ADDENDUM NO. 02

Wheatley Institute Third Floor Renovation

Project: Wheatley Institute – 3rd Floor Renovation

ADDENDUM NO. 2

ELEVATION - RECEPTION FEATURE WALL
SCALE: 1/2" = 1'-0" **5**

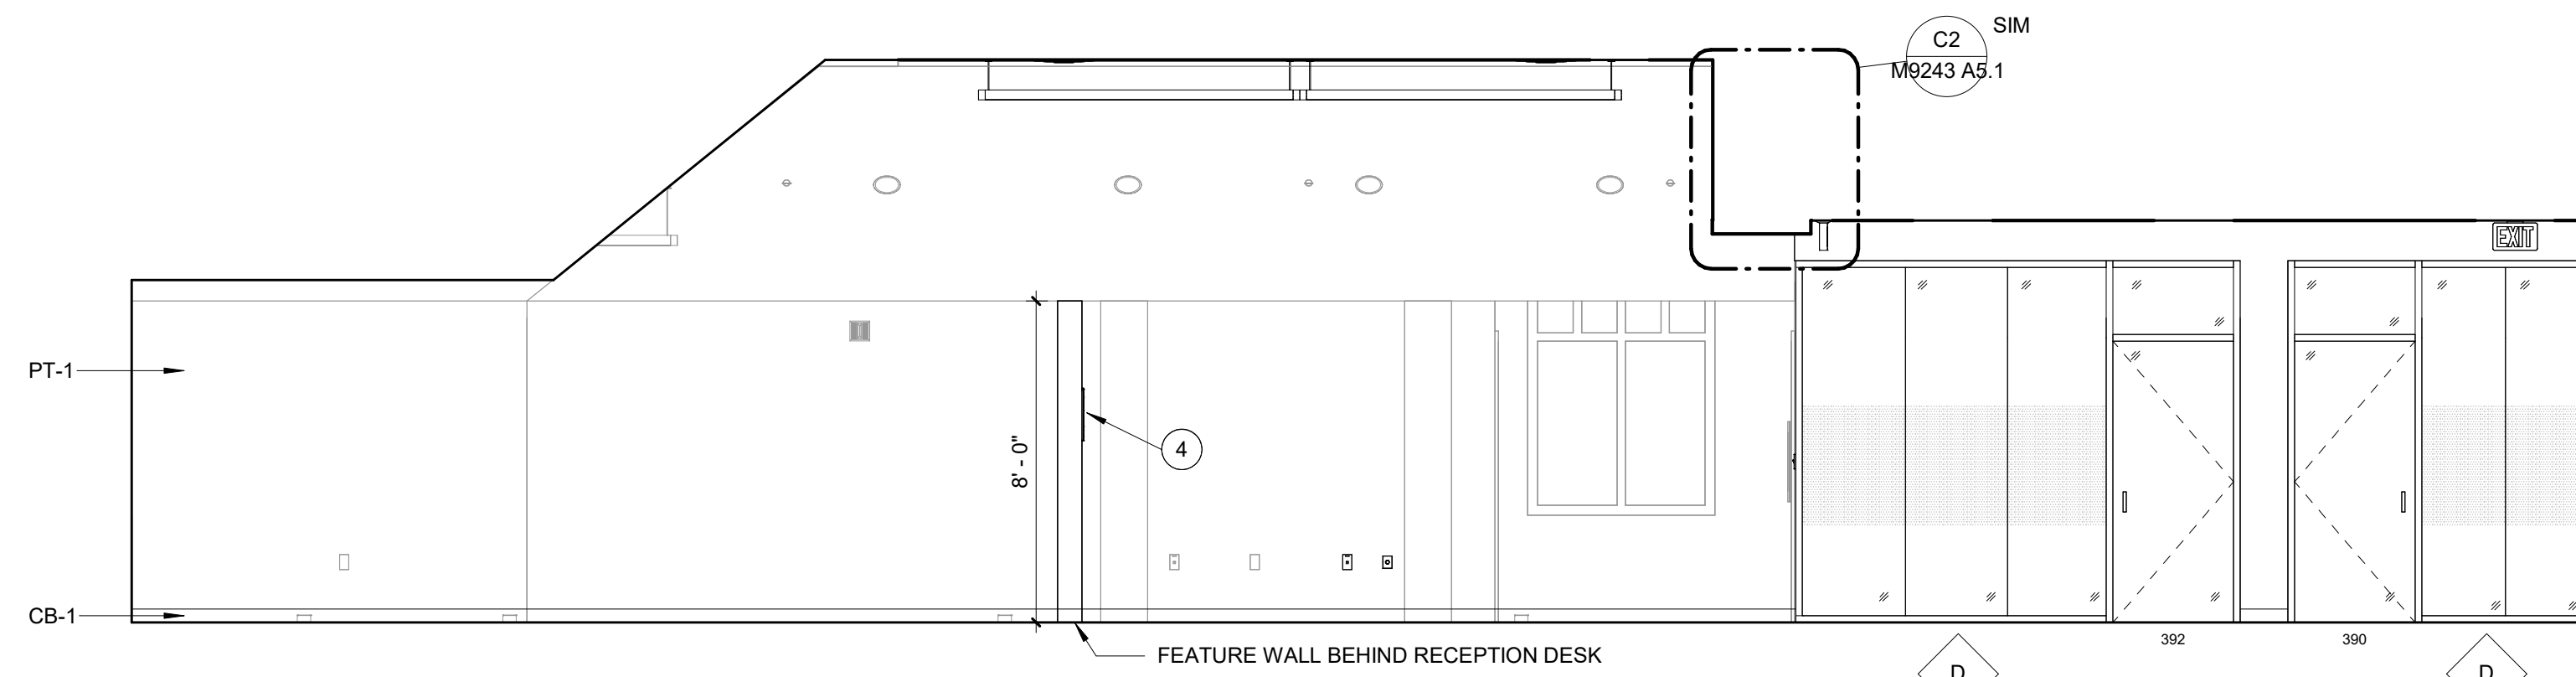
- REVISE: Thickness of wall assembly at reception feature wall to be 6”.
5. **Sheet A4.2**
 - ADD: Location of new Fire/Smoke Damper in storage room 388 along with Return-Air-Grill in wall in Initiative Room 342-11.

M9243
E1.1

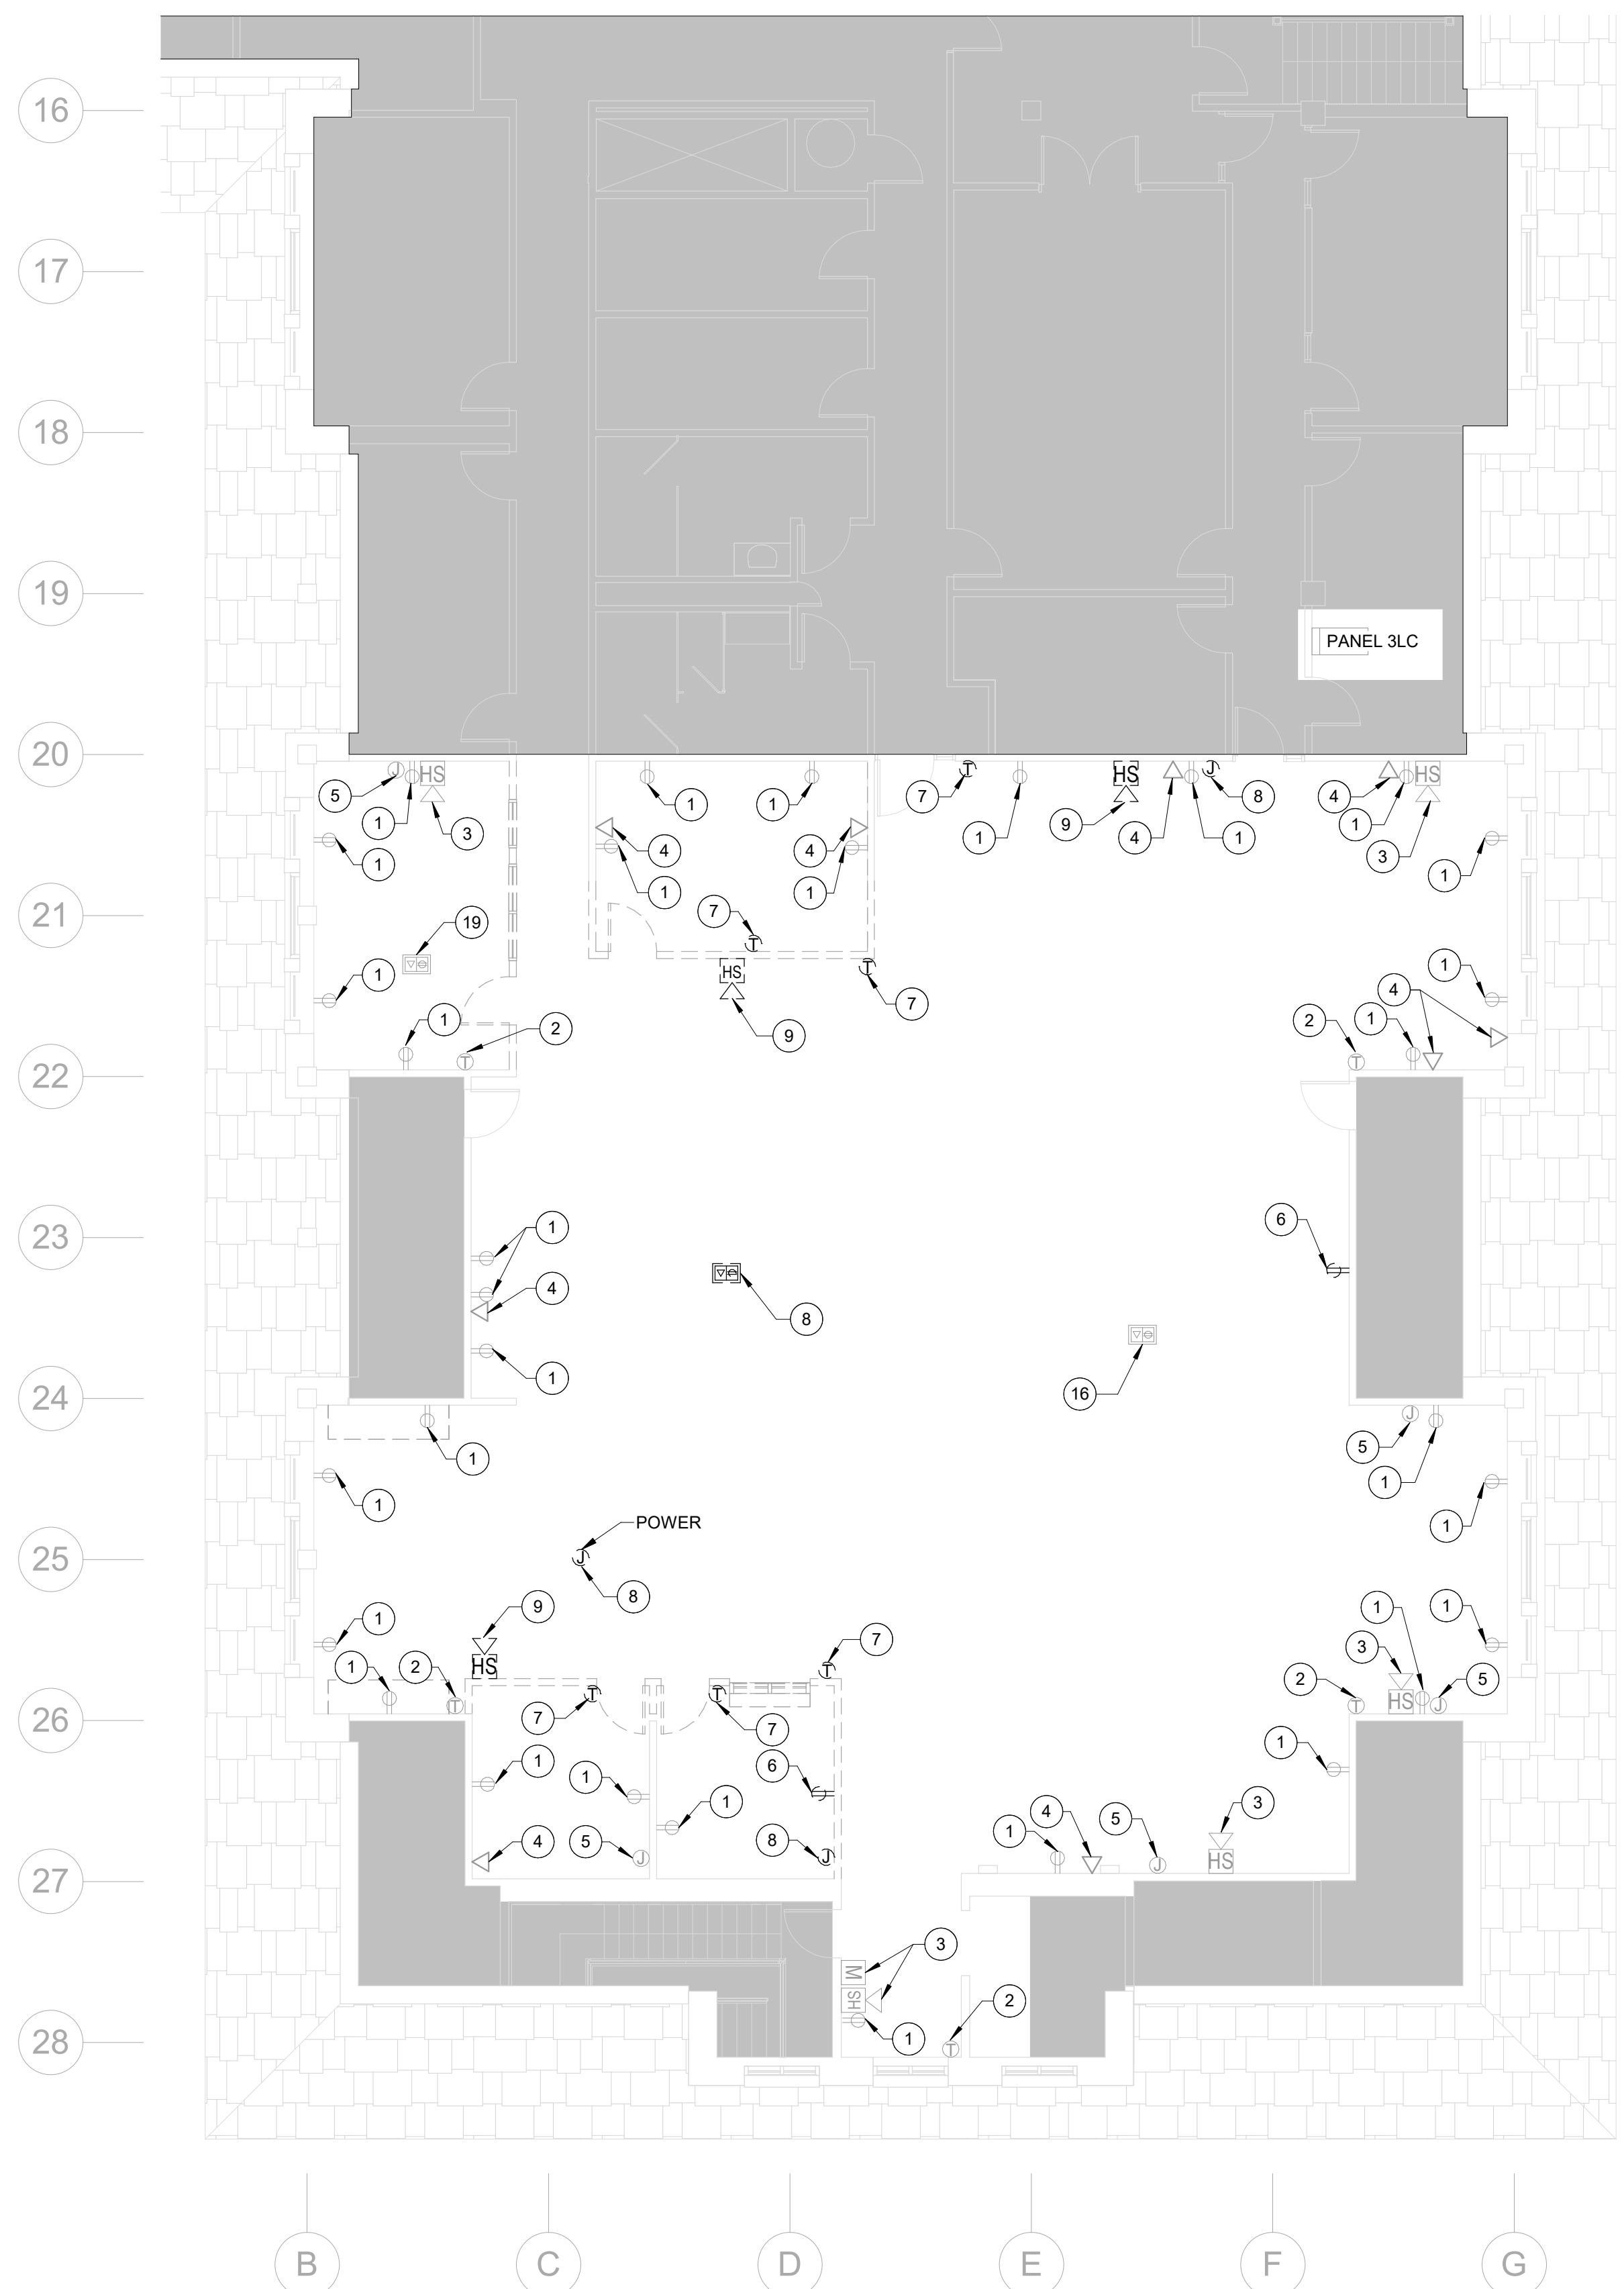
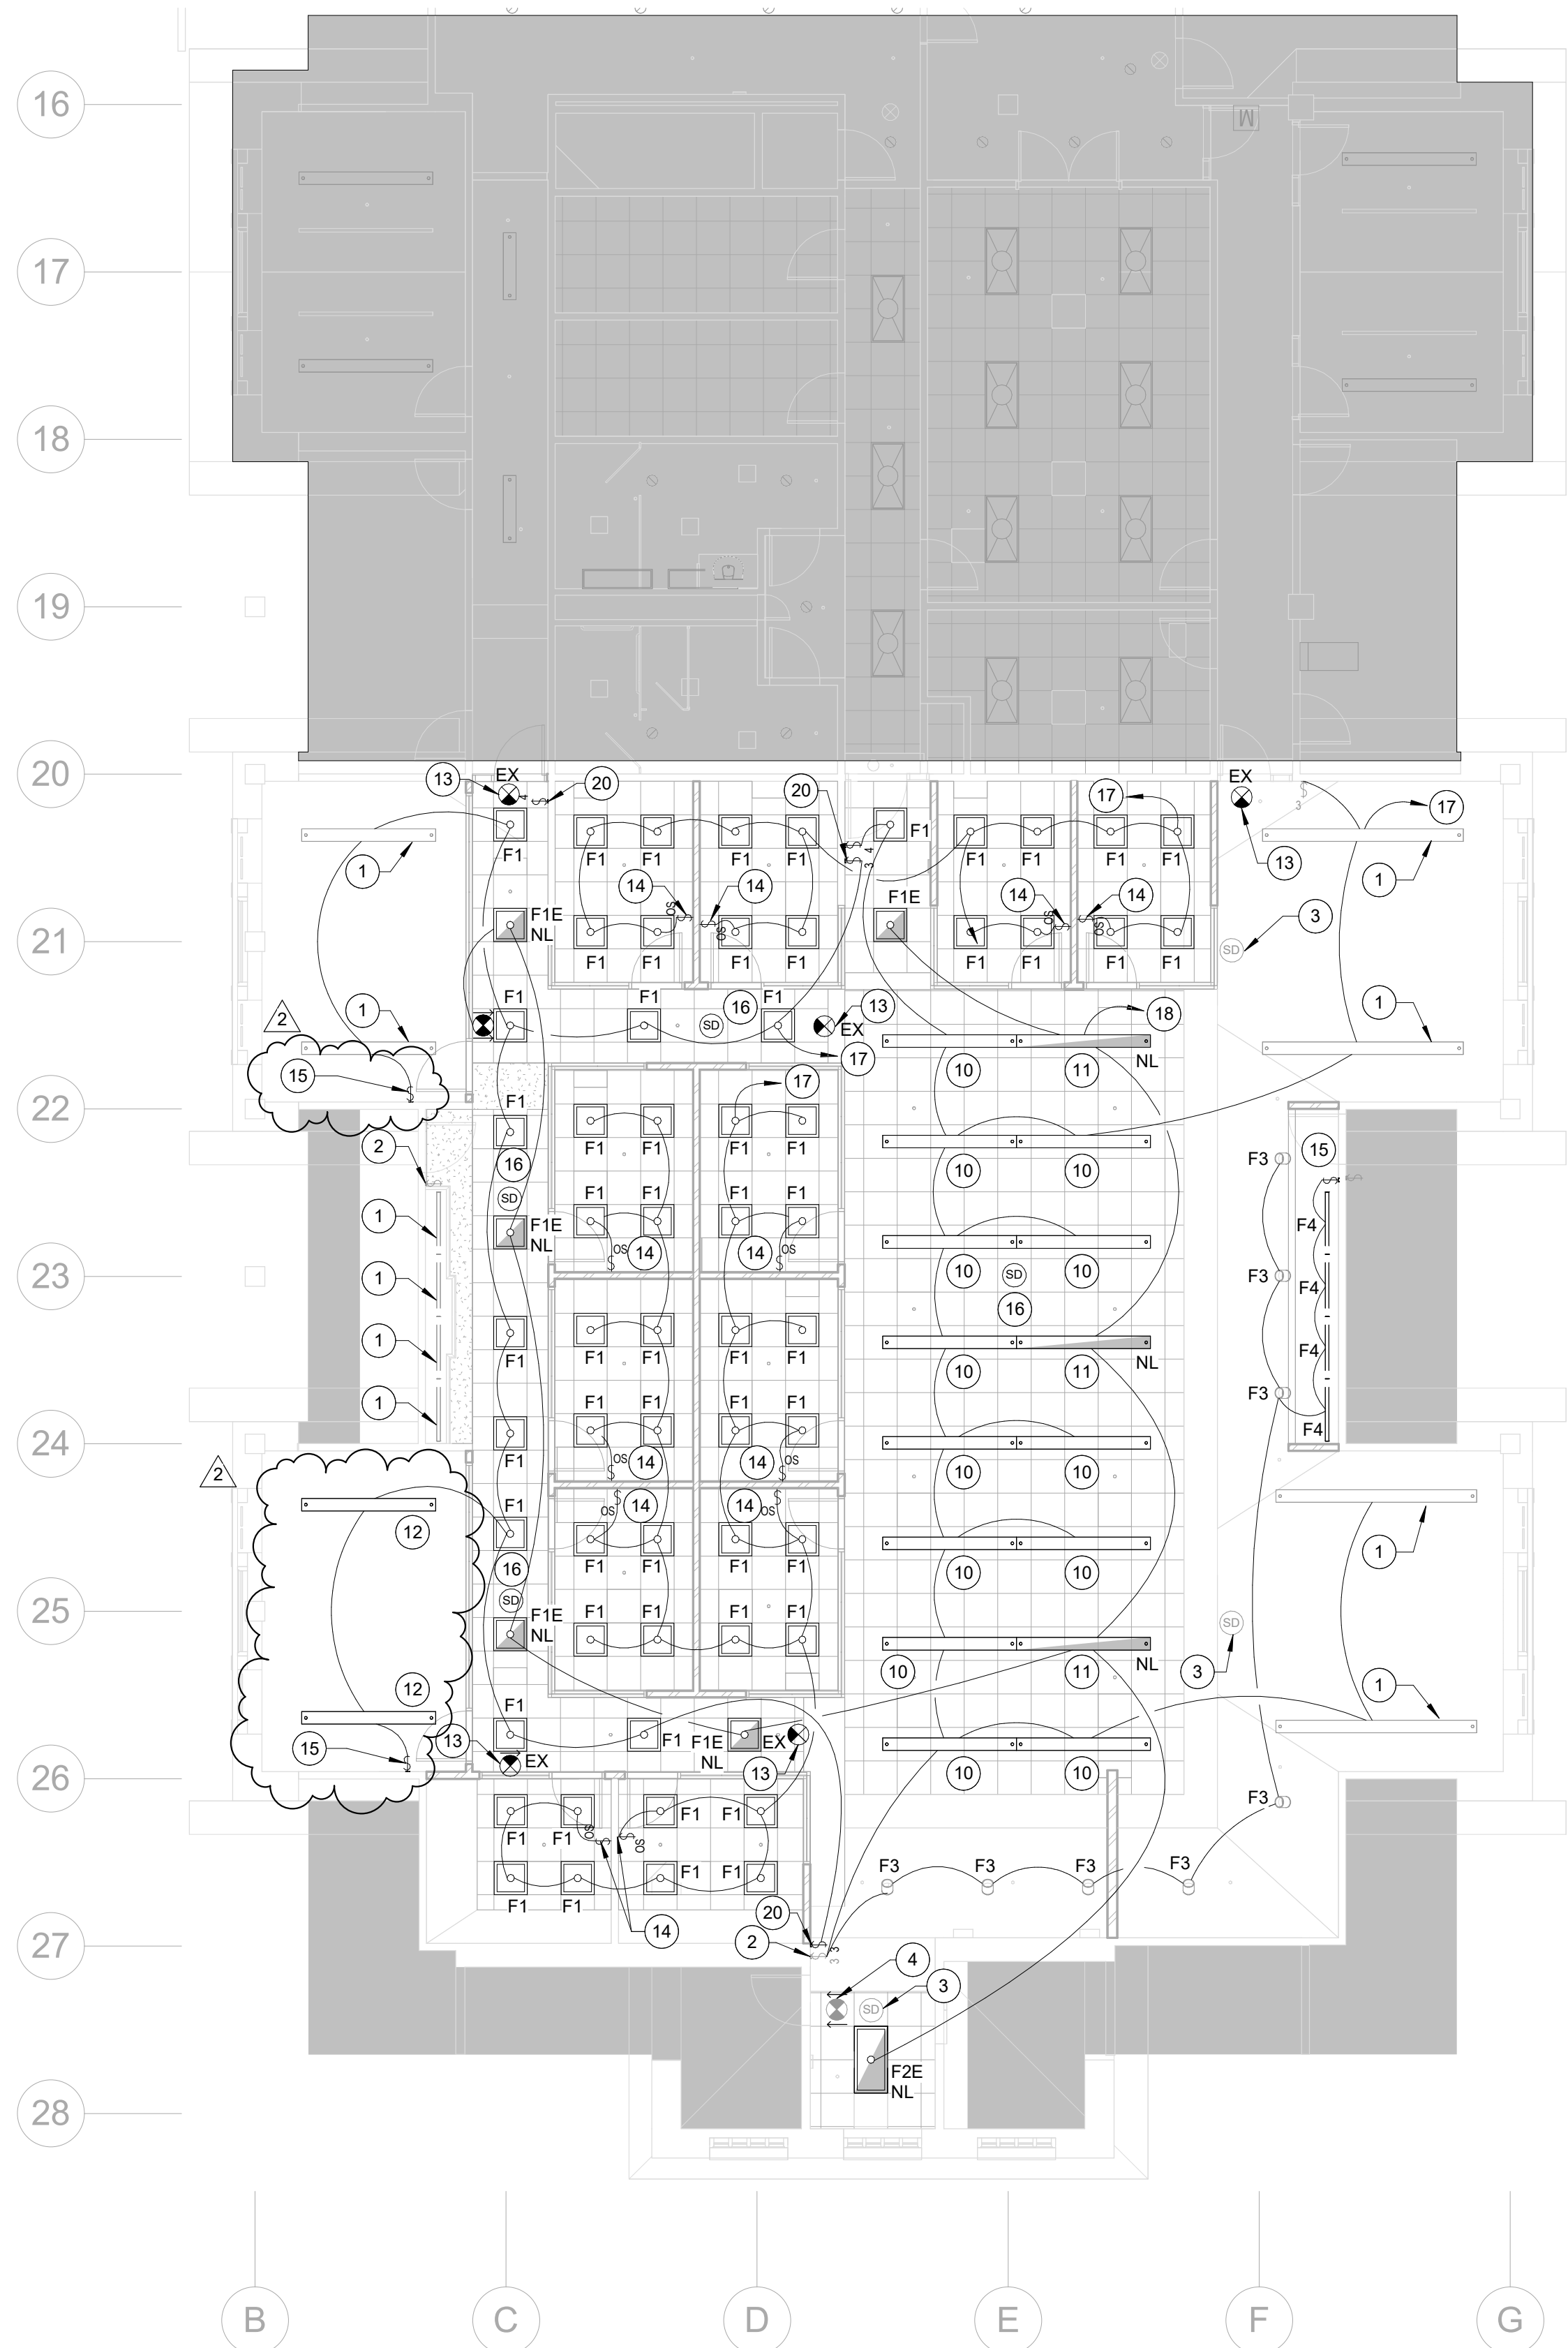
- REVISE: Door Schedule to show Door Hardware Set numbers for all doors within project scope.
8. **Sheet E1.1:**
 - ADD: Two new floor penetrations (power only) through floor slab in south-east portion of open office area – rm 342 with associated sheet keynote 21 to new floor plan.

- ADD: Connections to Fire/Smoke Damper in Storage Room 388 with associated sheet keynote 22 to new floor plan.
 - ADD: TVSS connection to north wall of Initiative #2 rm 386 with associated sheet keynote 23 to new floor plan.

- 22 CONNECT NEW FIRE DAMPER TO FIRE ALARM SYSTEM. PROVIDE ALL REQUIRED CIRCUITING FOR A COMPLETE INSTALLATION.
- 23 INSTALL NEW TVSS RECEPTACLE AT 72" A.F.F. IN LINE WITH EXISTING RECEPTACLE BELOW. PROVIDE 3/4" WITH (2)#12, (1)#12 GND., THHN, CU., FROM RECEPTACLE TO NEAREST AVAILABLE RECEPTACLE CIRCUIT.
